Balby to Woodfield Cycleway - Path Gradients audit

for: Doncaster Metropolitan Borough Council

Final Draft Dec 2007

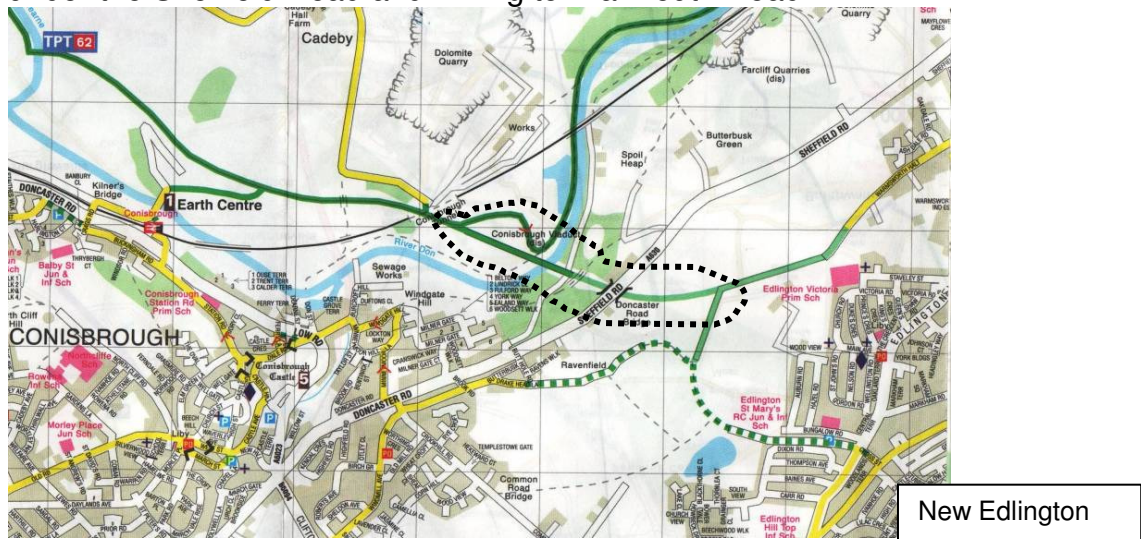
- a recommended maximum gradient of 3% (1 in 33.3)
 - an absolute maximum gradient of 5% (1 in 20) for lengths up to 100m.
 - Where steeper slopes are unavoidable the limiting gradient is 7% (1 in 14.3) for lengths up to 30m.
 - For those with limited mobility – wheelchair users – an absolute maximum gradient of 8% or 1 in 12 is recommended.
 - For gradients of paths greater than 5% handrails and landing areas are suggested
- 4.3 These gradients along with the existing one are illustrated below in **Figure 1** for a rise of 0.5 cm

- 4.4 As can be seen from the above diagram, the existing slope is fairly steep at 18.5% or 1 in 5.4. Doncaster MBC plans to improve the gradients by providing 2 paths – a straight one with a 1:11 gradient and a curved one with a 1:15 gradient by adding material on top of the landfill. – see **Figures 3 and 4** – which also show other path options with more gentle gradients,

Figure 2 – Plan of proposed cycle paths options

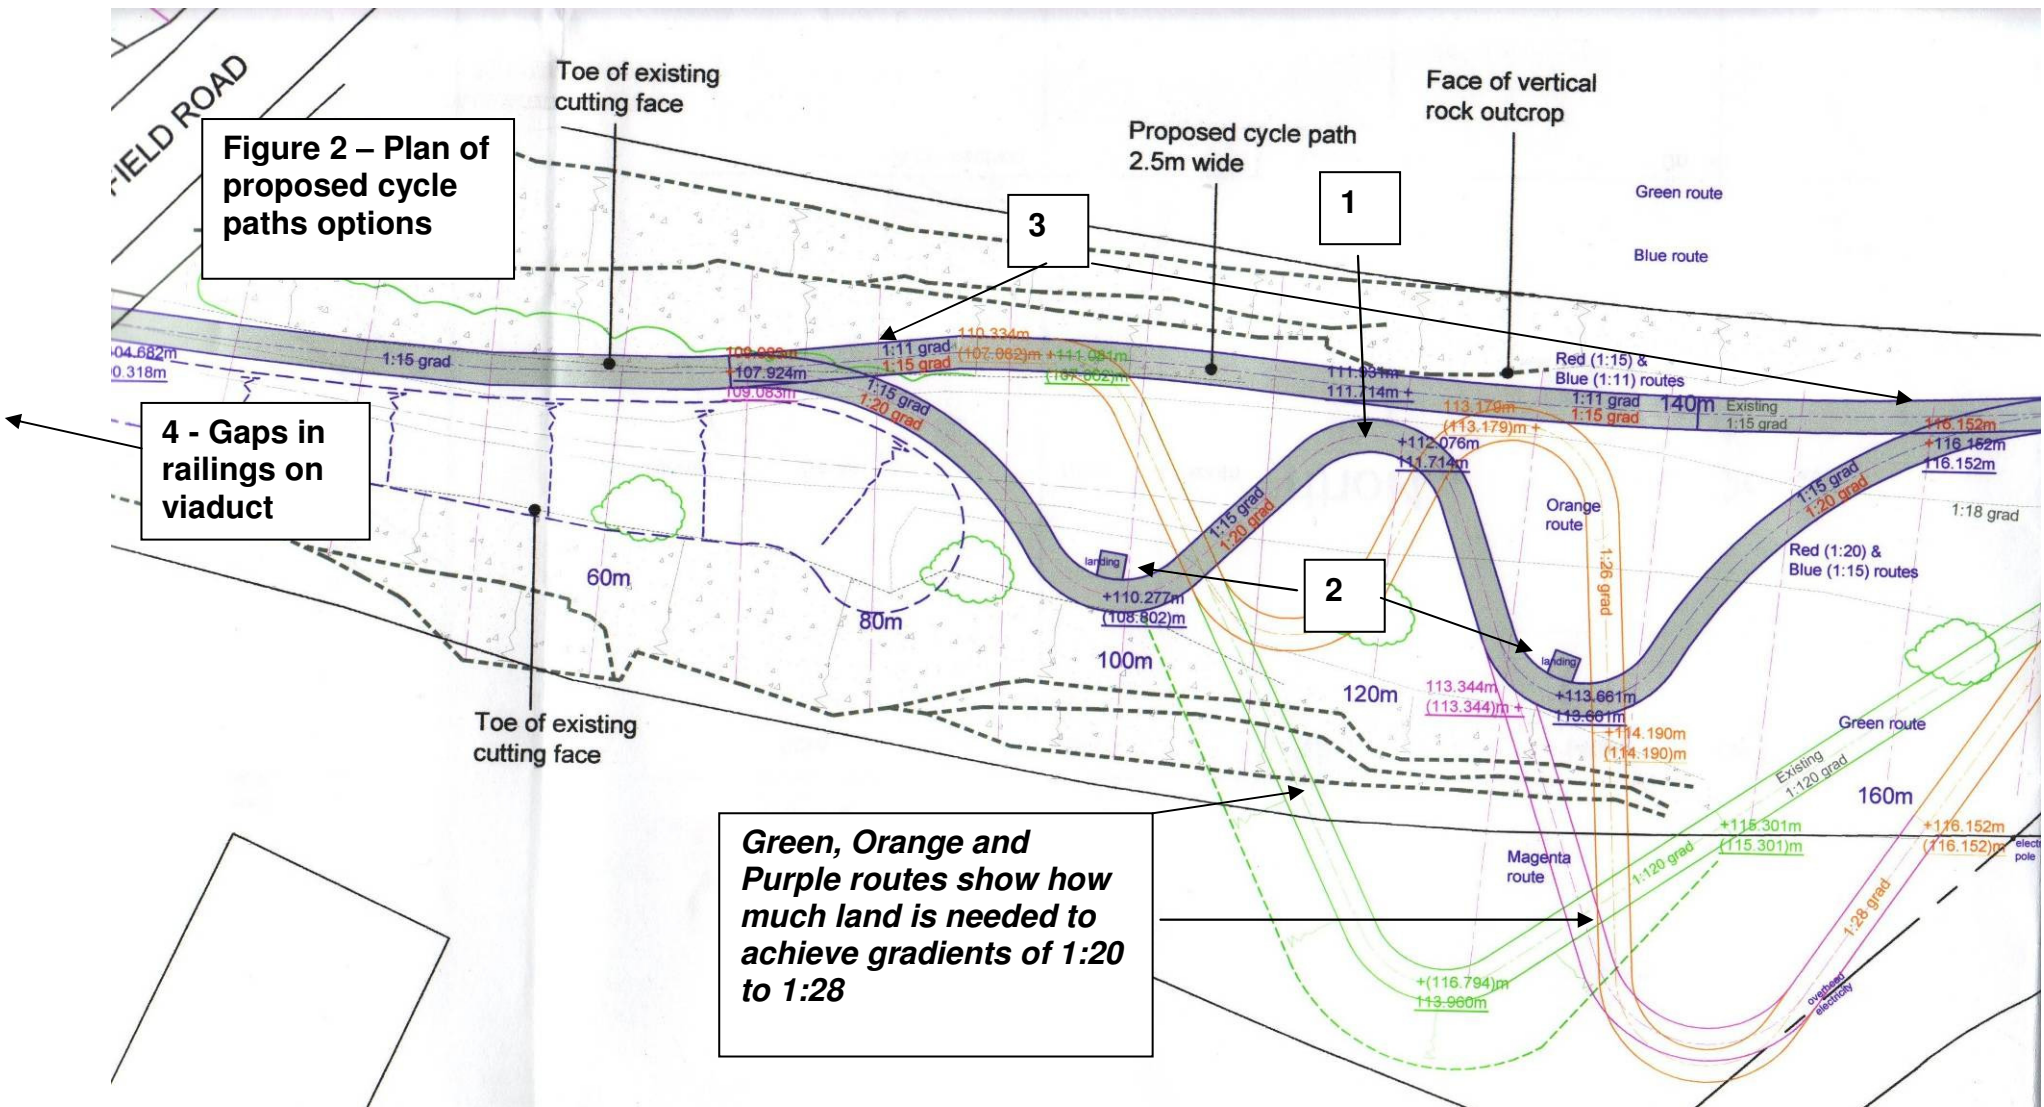
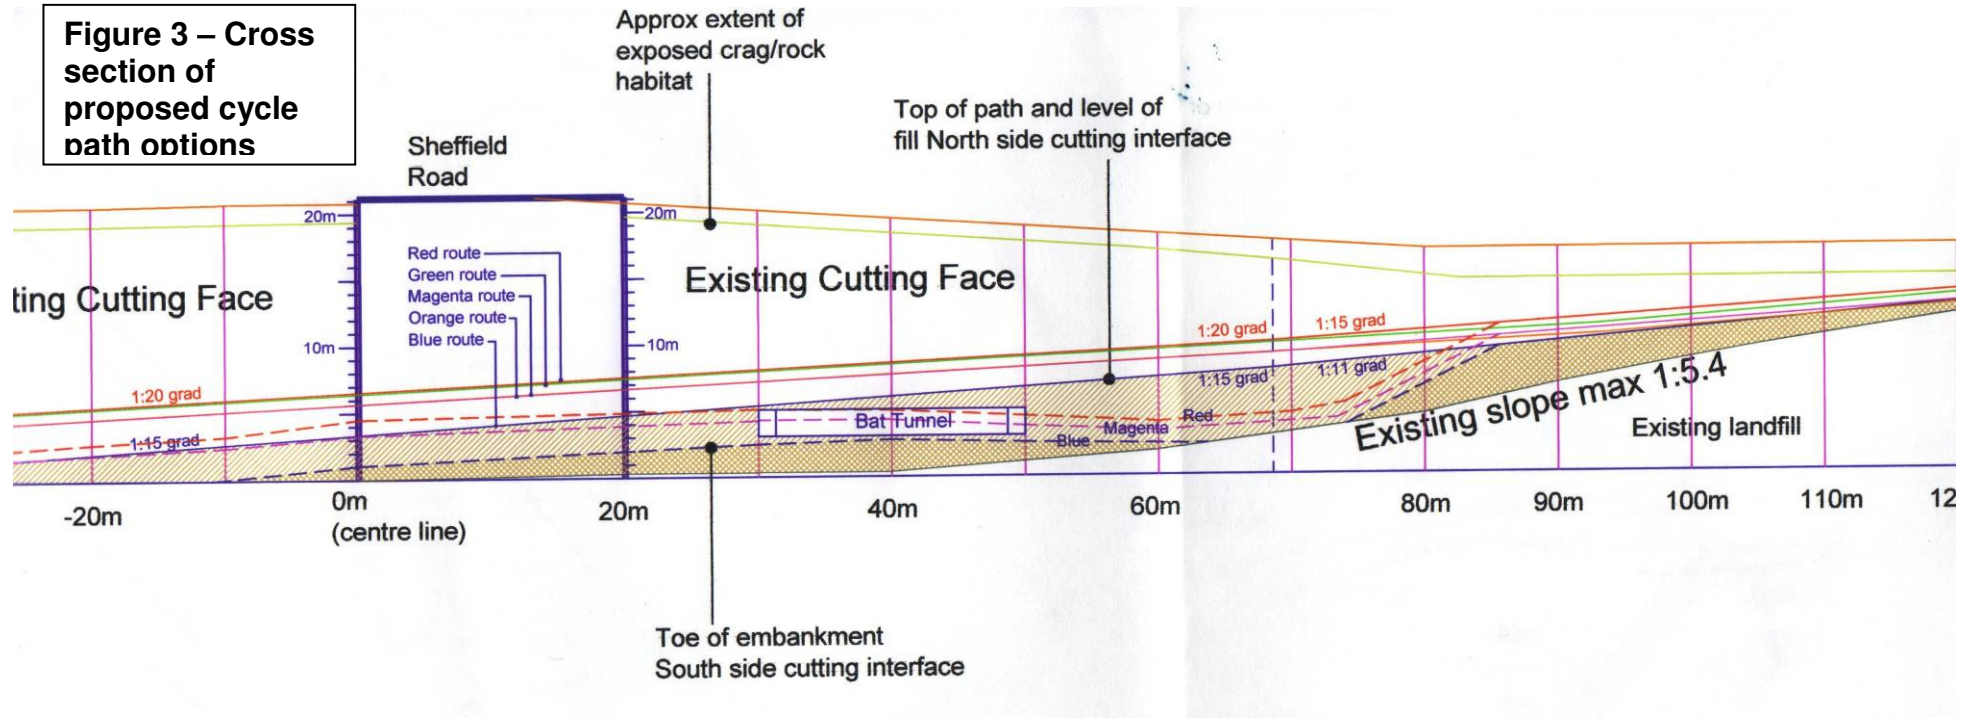
Plan Ref	Issue	Recommendation
1	<p>Existing ramp gradient at 18.5% or 1 in 5.4 is too steep for comfortable cycling and for other wheeled users.</p> 	<p>Given the site constraints of a deep cutting limiting the width available to curve the path as well as the geological and ecological importance of the site it is not possible to achieve the ideal recommended gradient of 3% and hard to achieve a 5% gradient without considerable landfill which may affect the site's ecology and geology.</p> <p>A gradient of 7.5% or 1 in 15 can be achieved by curving the path to help users get up the hill. This would be a big improvement on the existing gradient. These sections of path would be limited to between 25 to 30m between turns as suggested in design guidance.</p> <p>This may require a handrail on one side as due to the gradient it will be classed as ramp.</p>

Plan Ref	Issue	Recommendation
2	<p>Landing stages on the uphill section shown joining the path at right angles and cyclists and other users will cut the corners to get into them</p>	<p>Show a 2-4m radius in and out of the landing stages to aid entry and exit for cyclists, wheelchair and pushchair users</p> 
3	<p>The proposed straight path with a gradient of 1:11 or 9% may lead to problems of cyclists speeding downhill intimidating other users and also does not leave much room for a rough surface for equestrian users .</p> <p>It may also require a handrail.</p>	<p>Consider not providing the straight path and discourage this movement by planting. This may give a bit more room for the curved path which would make the gradients slightly better.</p> <p>A handrail would also discourage users from taking a straight line downhill.</p>
4	<p>One section of the Conisbrough Viaduct has open railings and a potential safety hazard</p> 	<p>This section of the viaduct is in Sustrans ownership and it is suggested that they be required to provide either a mesh infill or railings with narrower gaps to enable the route to be used safely.</p> <p><i>Photo - bridge parapets with narrow railings on a new bridge over the Bingley Bypass</i></p>

- a) Install one curving path with a gradient of 1 in 15 or 7.5% or better instead of one straight path and one curving path.
- b) Discuss with Sustrans the need for improvements to make the railings section of the Conisbrough Viaduct safer by installing narrower railings or other measures.
- c) Amending the design of the landing stages to provide curved radius entry and exits as in plan ref 2.
